BENT GRASS EAST COMMERCIAL FILING 3

PRELIMINARY PLAN

8090 MERIDIAN PARK DR
EL PASO COUNTY, CO

PCD#: SP-20-010

COVER SHEET

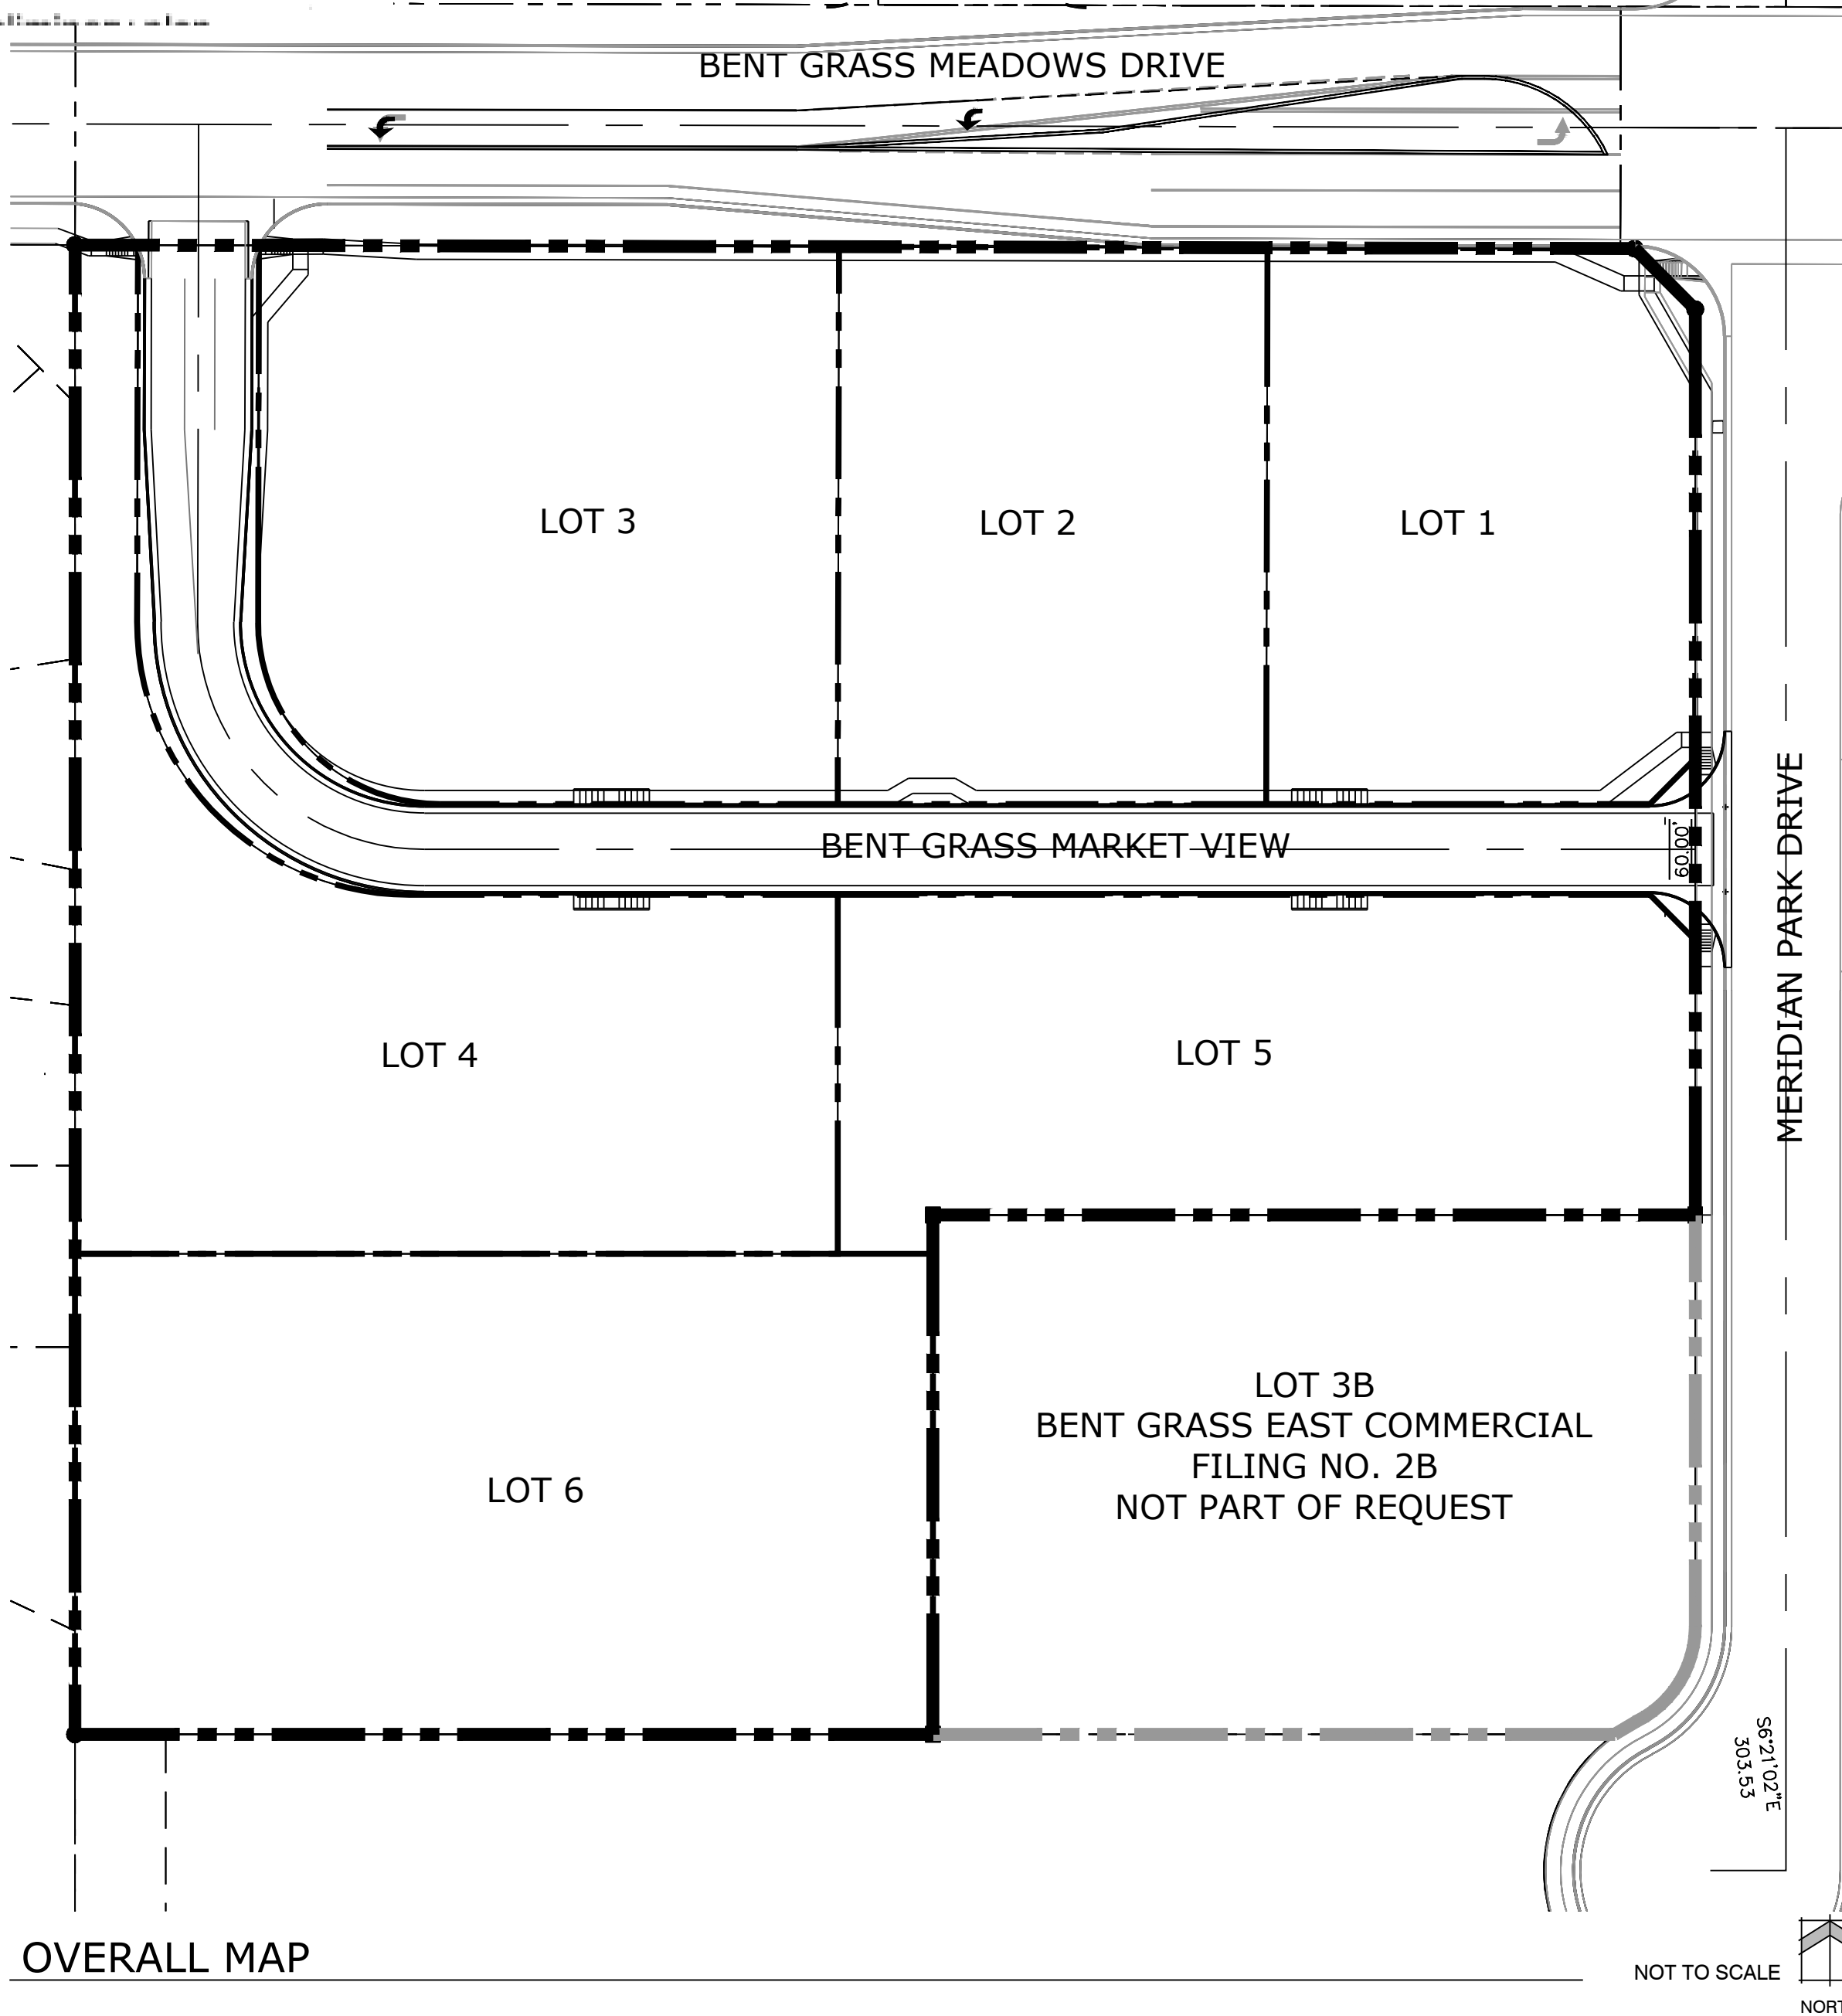
correct legal to include requirement on old checklist

Legal includes approximate survey tie to an accepted survey monument?

PRELIMINARY PLAN

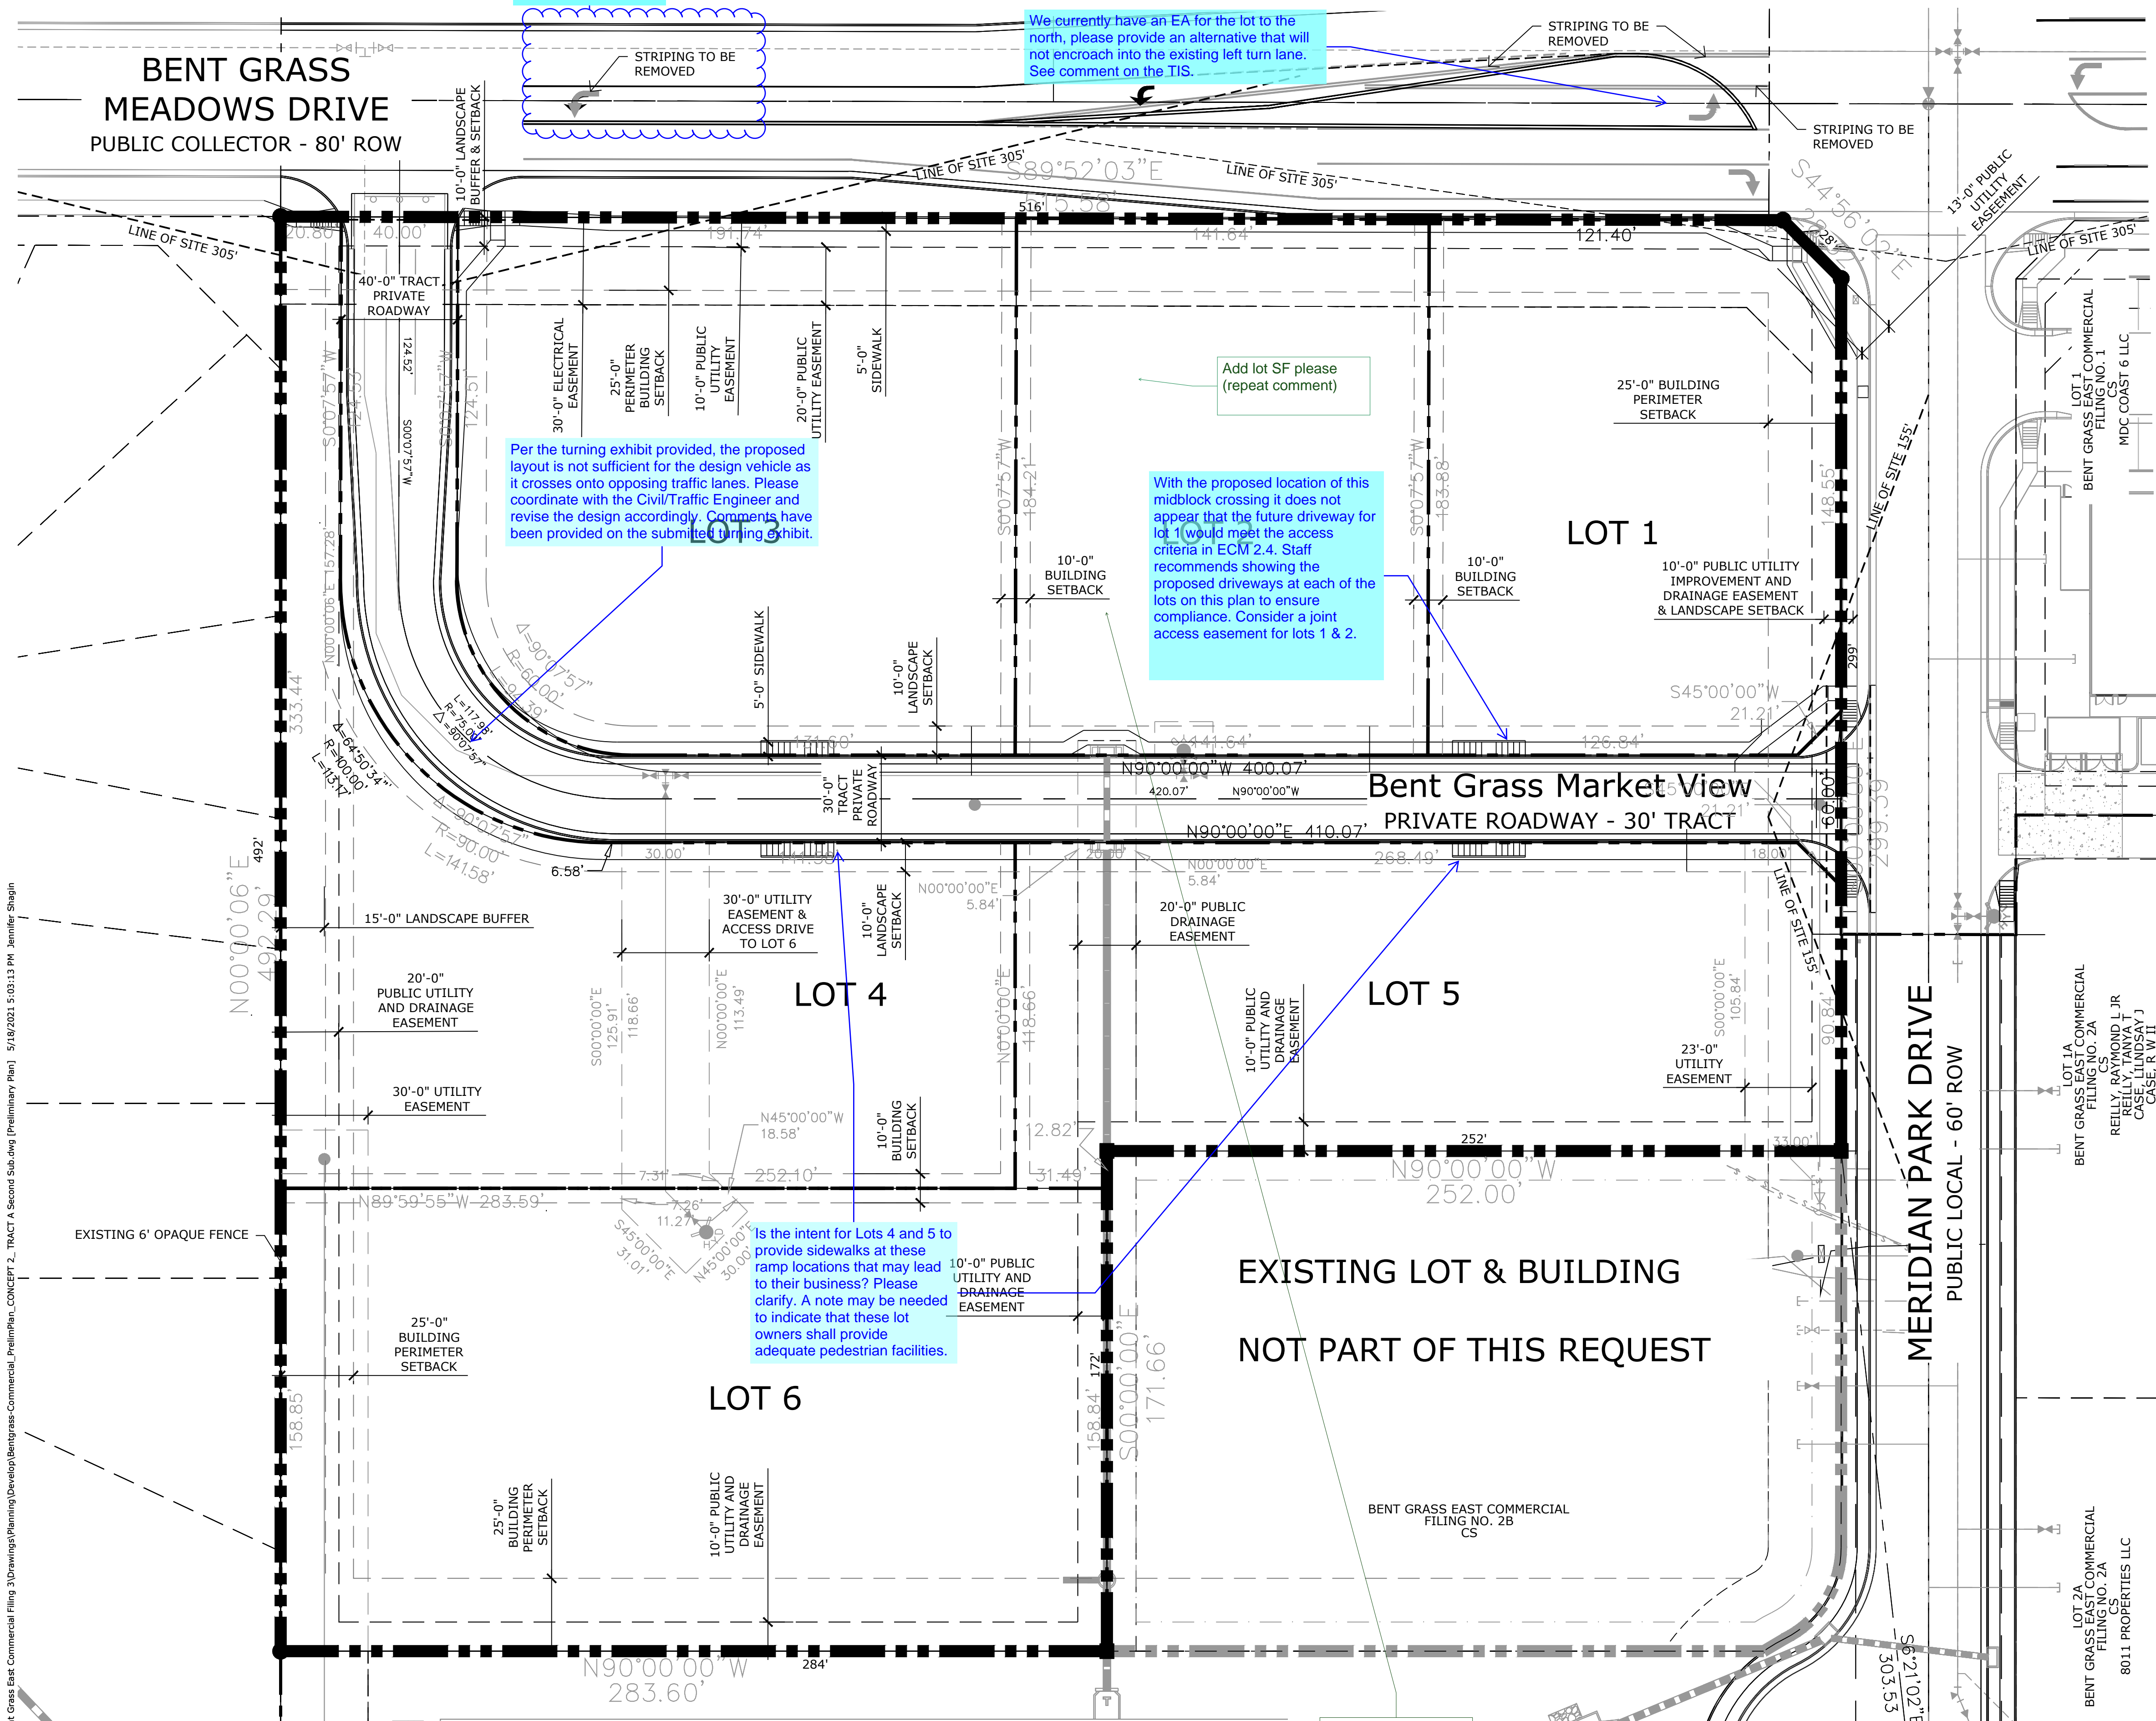
Please Clarify the removal of the striping as this left turn lane is indicated in the TIS

We currently have an EA for the lot to the north, please provide an alternative that will not encroach into the existing left turn lane. See comment on the TIS.

Per the turning exhibit provided, the proposed layout is not sufficient for the design vehicle as it crosses onto opposing traffic lanes. Please coordinate with the Civil/Traffic Engineer and revise the design accordingly. Comments have been provided on the submitted turning exhibit.

With the proposed location of this midblock crossing it does not appear that the future driveway for lot 1 would meet the access criteria in ECM 2.4. Staff recommends showing the proposed driveways at each of the lots on this plan to ensure compliance. Consider a joint access easement for lots 1 & 2.

Comments have been provided in the TIS that may affect the preliminary plan. Please coordinate with the traffic engineer and revise the plan as needed.

internal lot setbacks not required for structures
